ONE SYDNEY HARBOUR

BARANGAROO

R4A SUPPLEMENTARY DESIGN STATEMENT FOR S4.55 MODIFICATION
November 2020

Proposed P02 Floor Plan and Vent pipe zone Blow-up

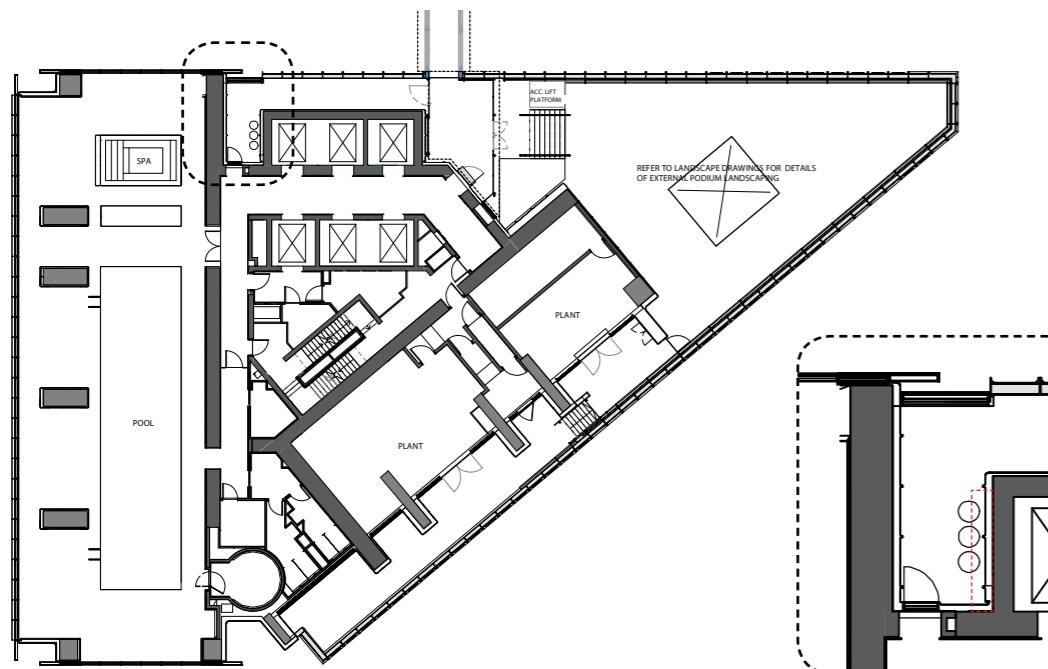
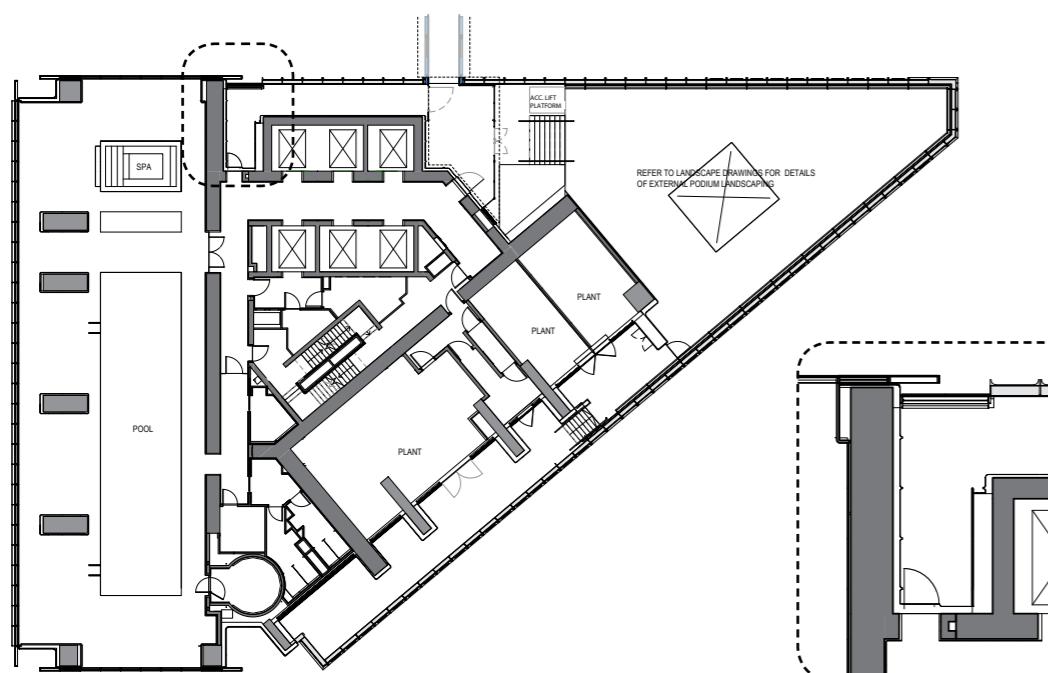
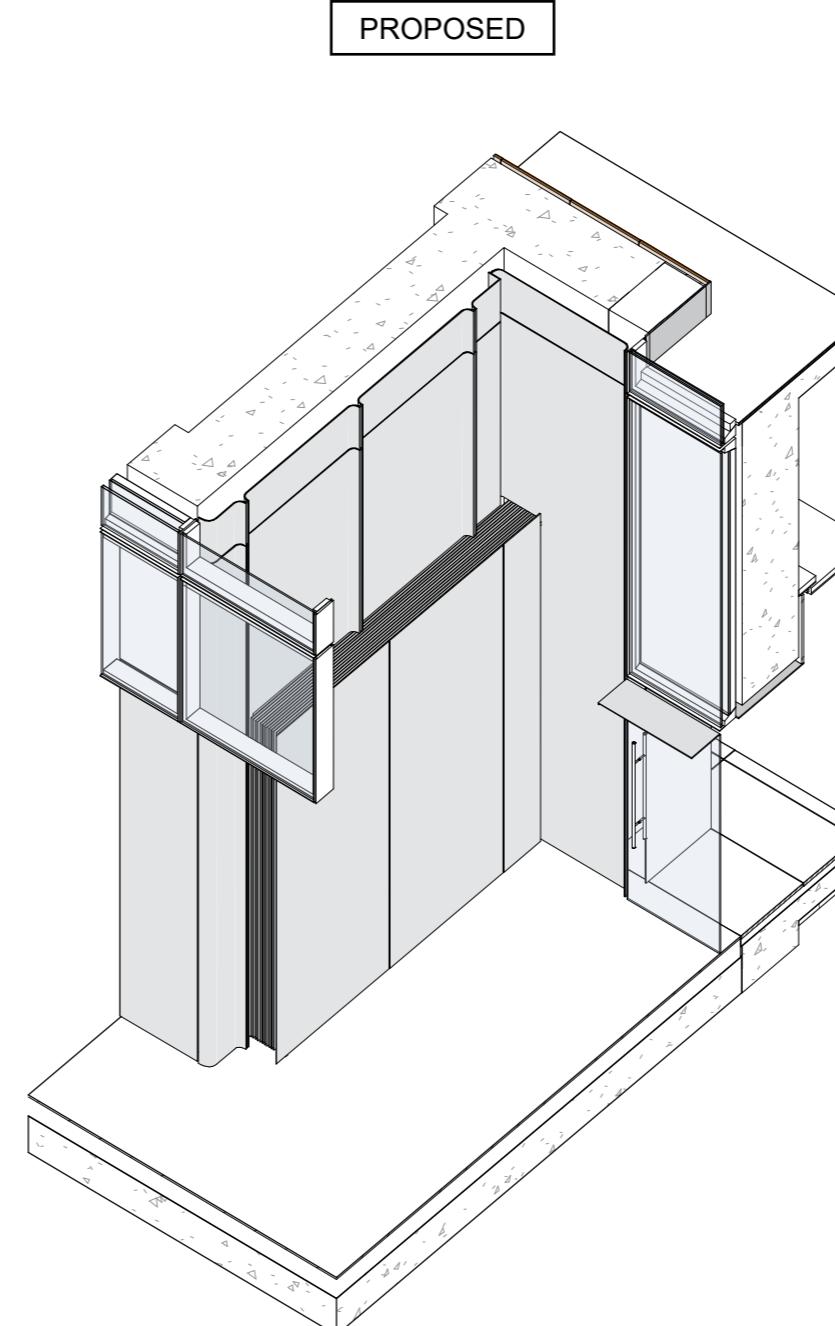
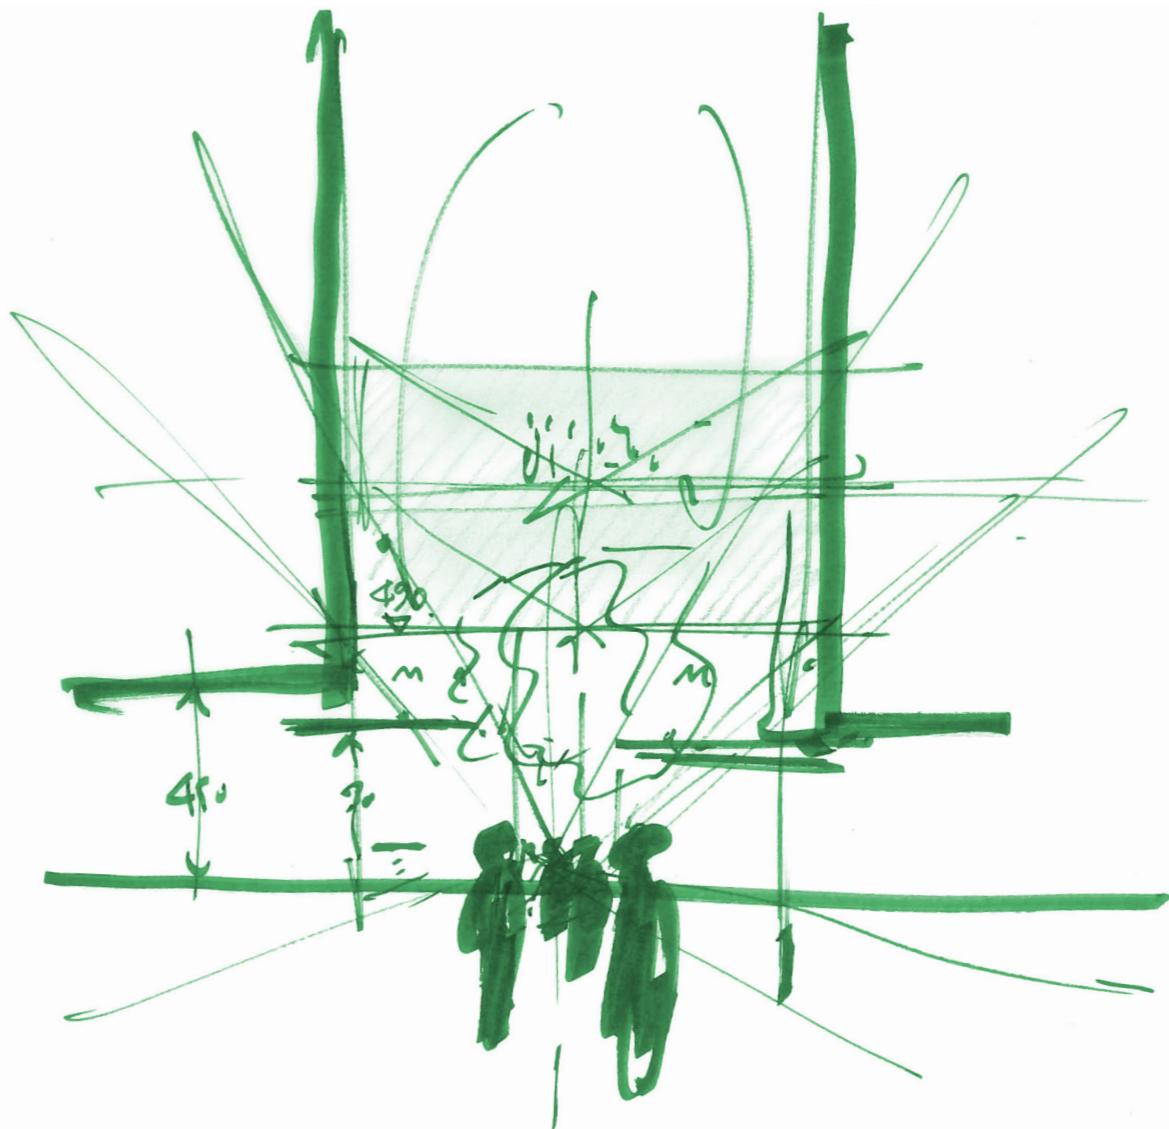
An amendment is also proposed to the vent pipes on P02 level close to the south east lift core facade.

The approved cylindrical flue solution was reworked to better reflect the design of the facade. The proposed scheme have the pipes arranged inside a cabinet-like structure, preserving the facade modularity and finishes, resulting in a visually integrated outcome.

This change was also driven by the aim to improve the circulation at the adjoining door. As show by the red dashed line in the approved vent blow-up, the proposed solution has a significantly smaller footprint, increasing the clear width leading up to the door in that area.
